INDUSTRIAL BUILDING #29 MAJESTIC COMMERCENTER FILING NO. 8 & 11

MAJESTIC COMMERCENTER
FILING NO. 8 & 11
1ST MAJOR AMENDMENT
COVER SHEET

NO.	DATE	REMARKS
1	01-03-2020	MAJOR AMENDMENT

SITE PLAN

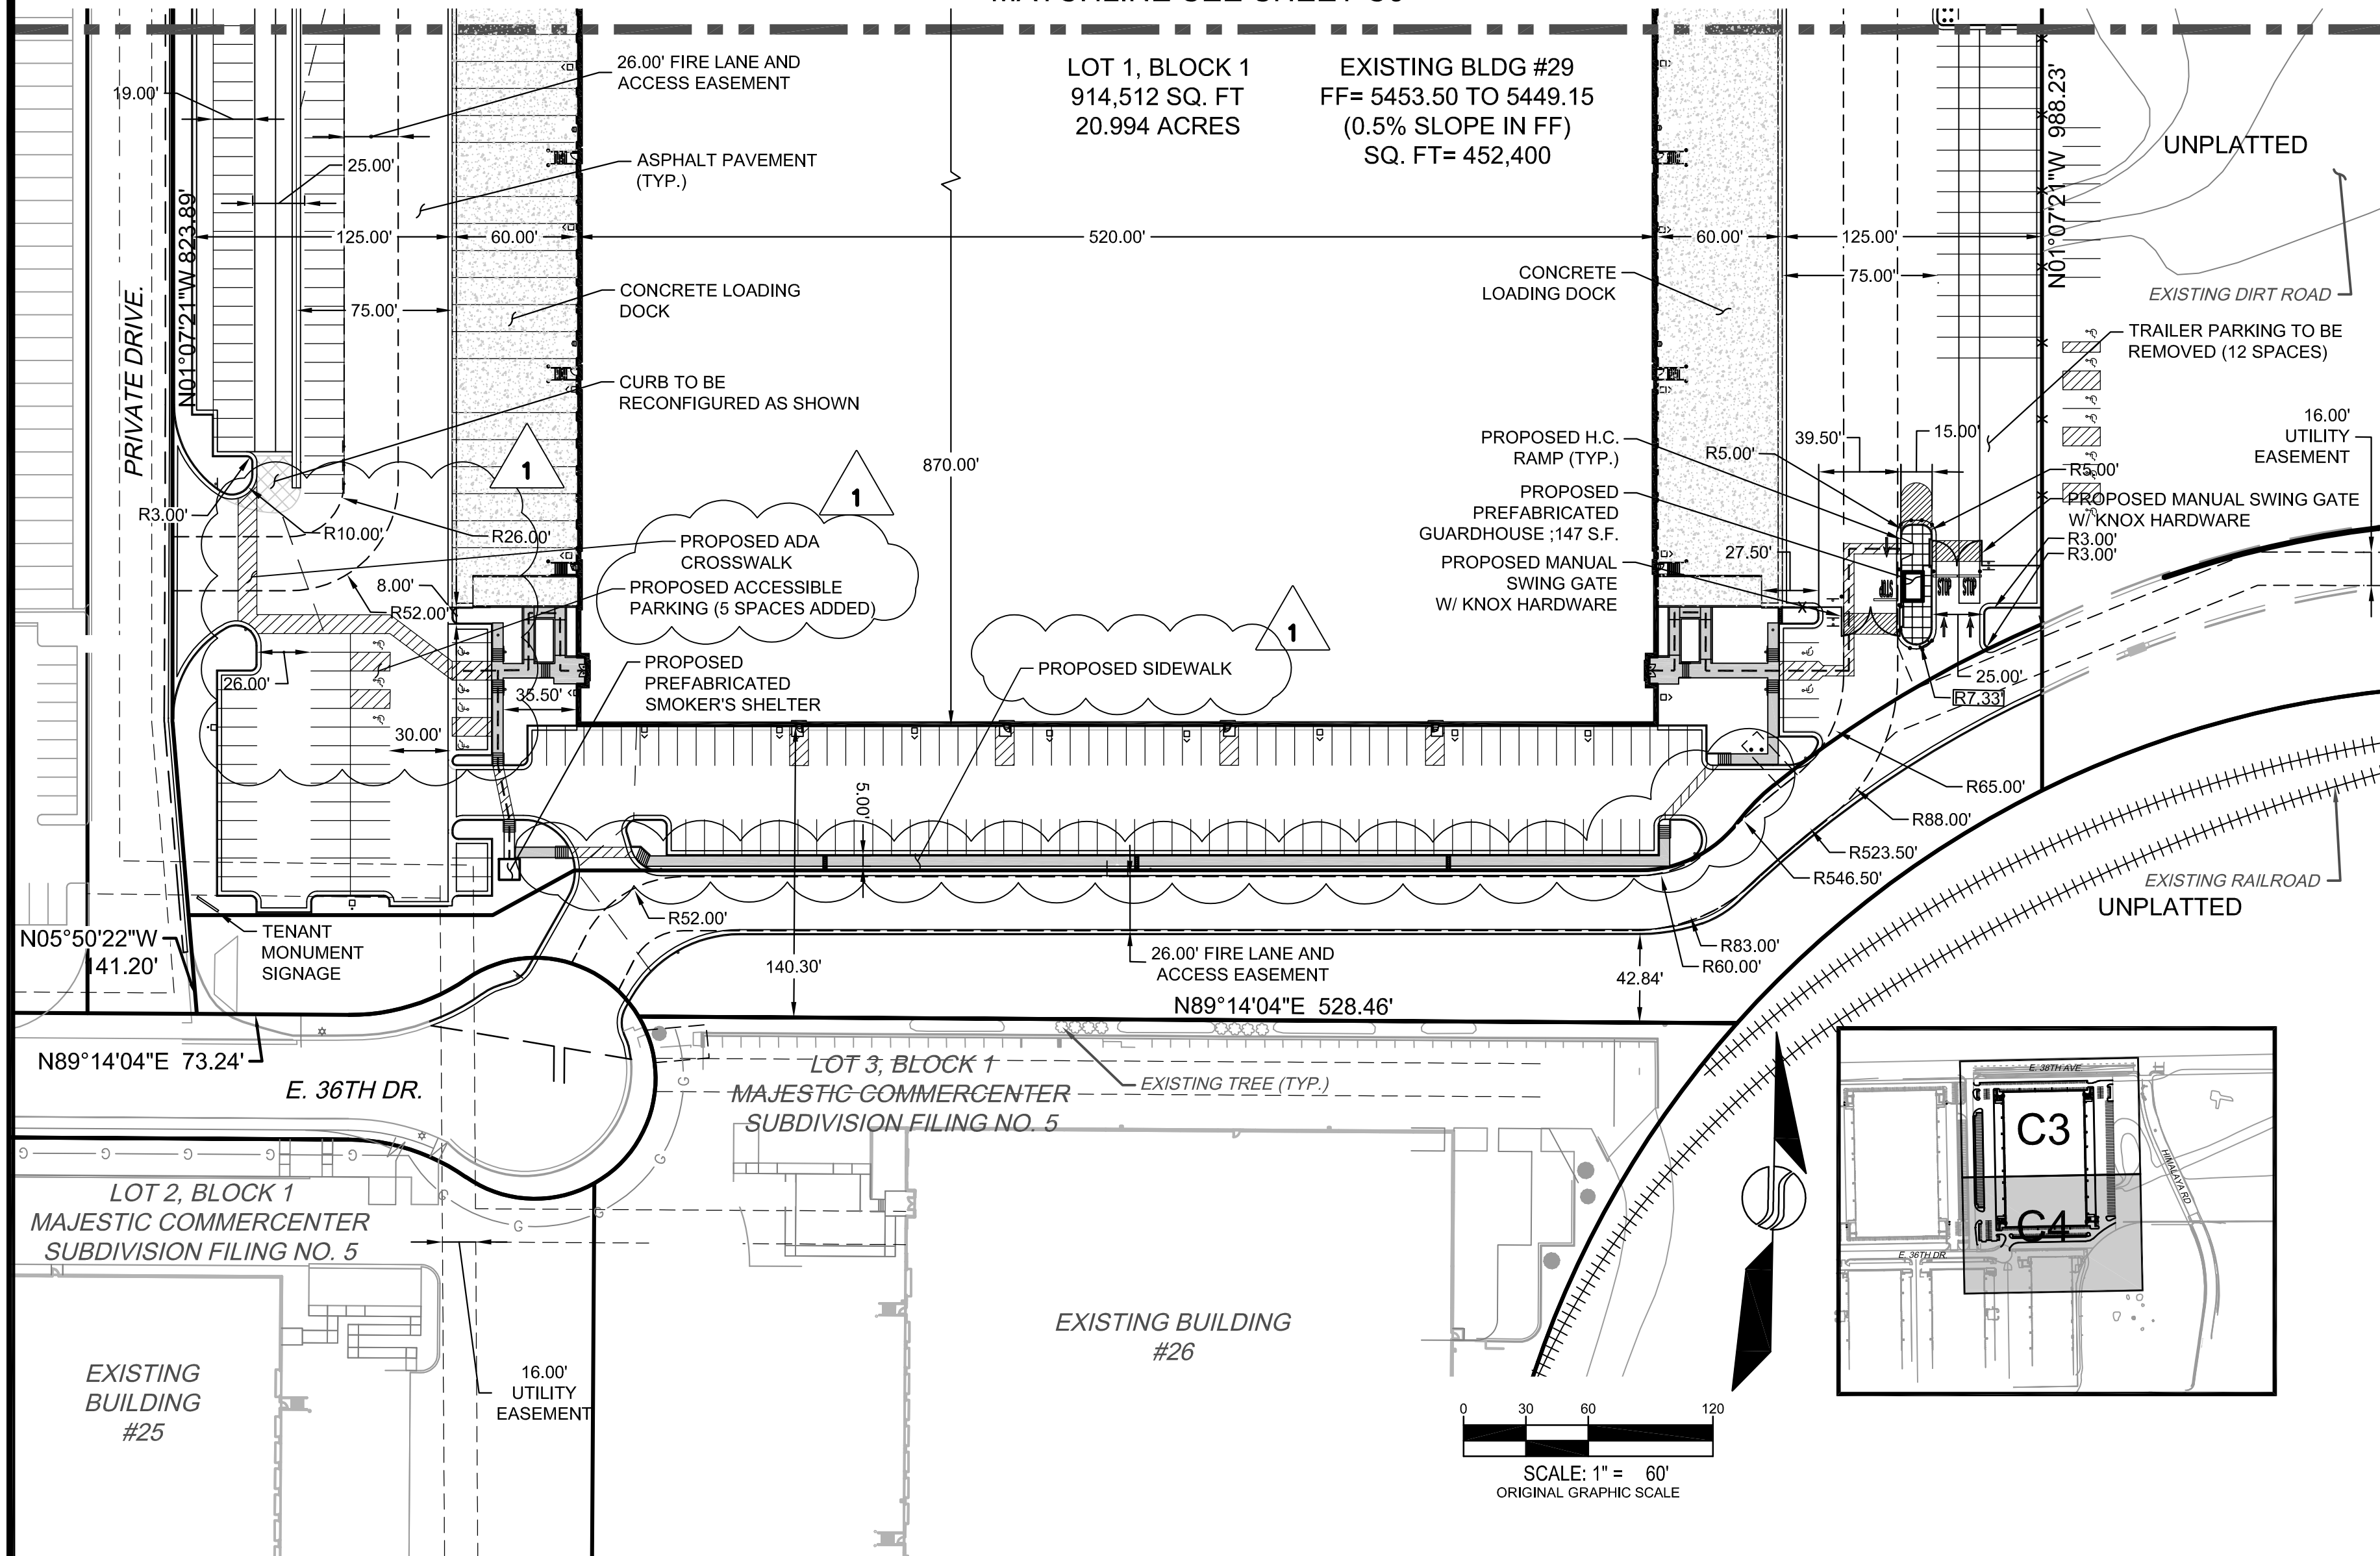
The site plan will not be approved by public works until the preliminary drainage letter/report is approved

Understood, thank you.

Typically a site plan amendment will not require new Mylars and new signatures because we will use the previous plan set. With the next submittal please use the existing coversheet and add deltas on the cover and throughout. If you have question how to best approach please give me a call.

Understood, the original cover sheet is now utilized and deltas are provided where necessary.

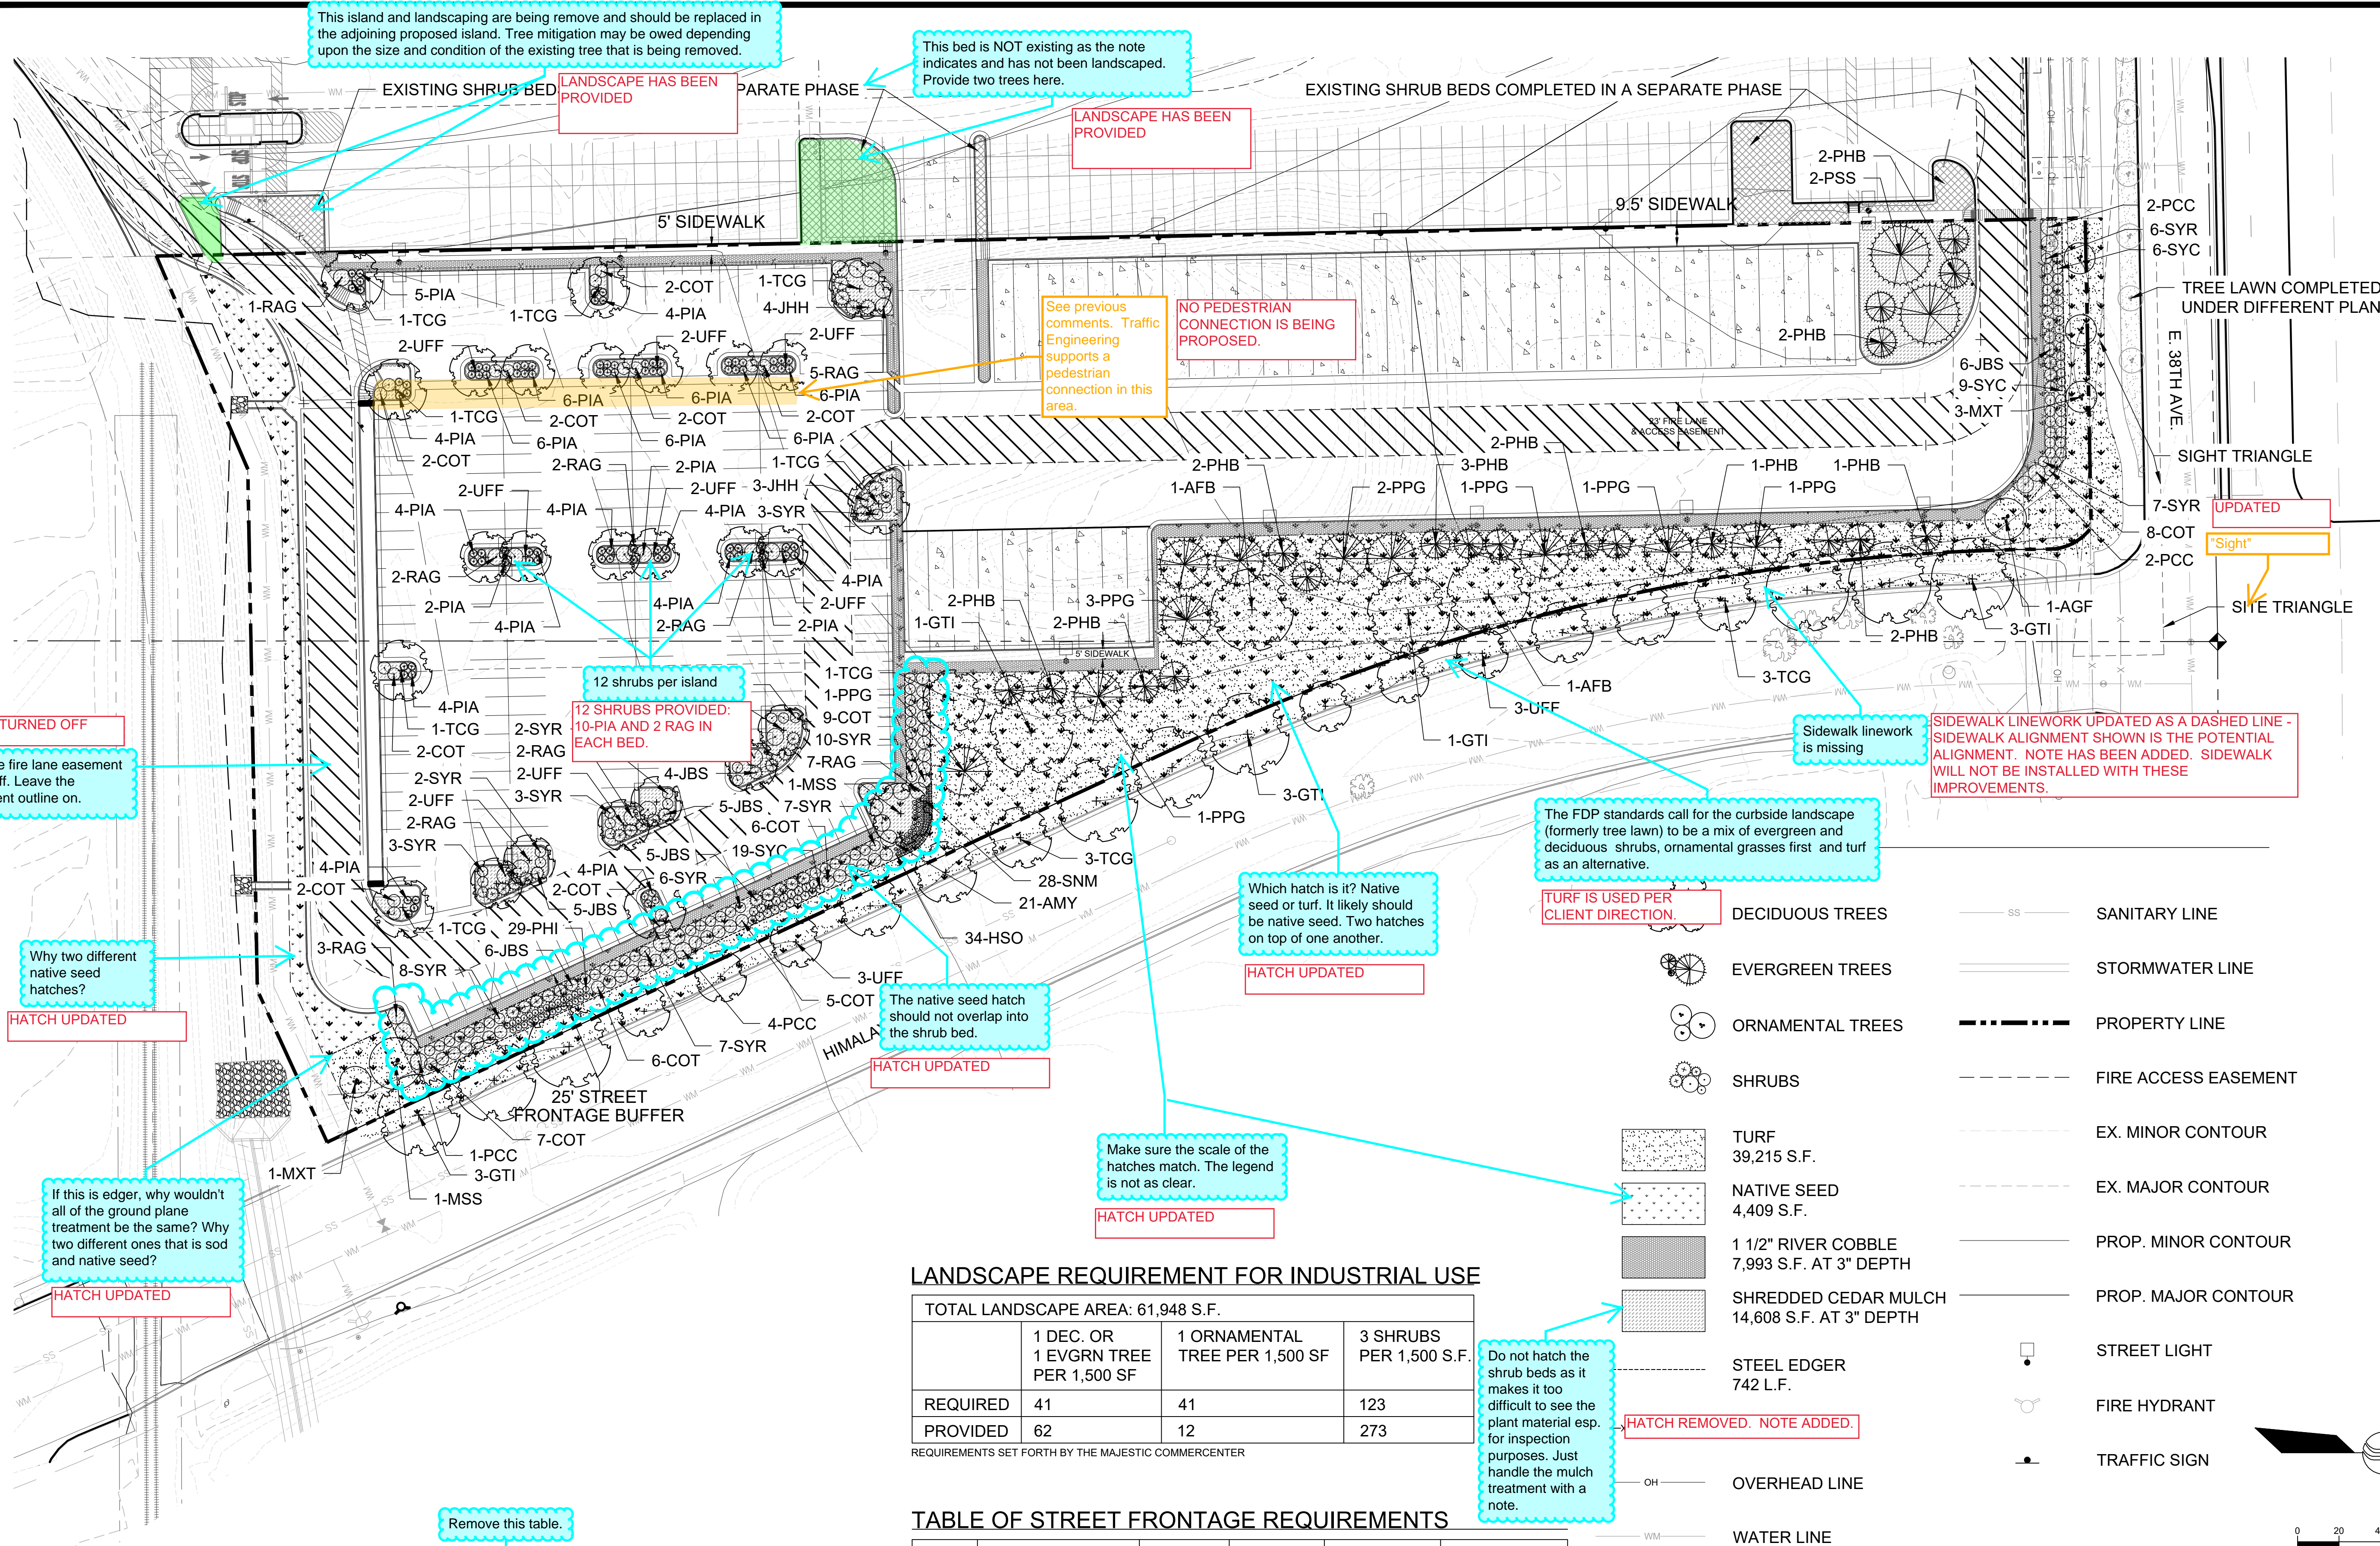
Should be 33% or less. Make the large sod areas native seed. No need to have high water use sod in those spaces.

HATCH TURNED OFF
Turn the fire lane easement hatch off. Leave the easement outline on.

Why two different native seed hatches?

If this is edger, why wouldn't all of the ground plane treatment be the same? Why two different ones that is sod and native seed?

Remove this table.

REQUIREMENTS SET FORTH BY THE CITY OF AURORA
Turf is used per client direction.
Property line prevents the use of larger trees.

HATCH UPDATED

HATCH UPDATED

TABLE REMOVED
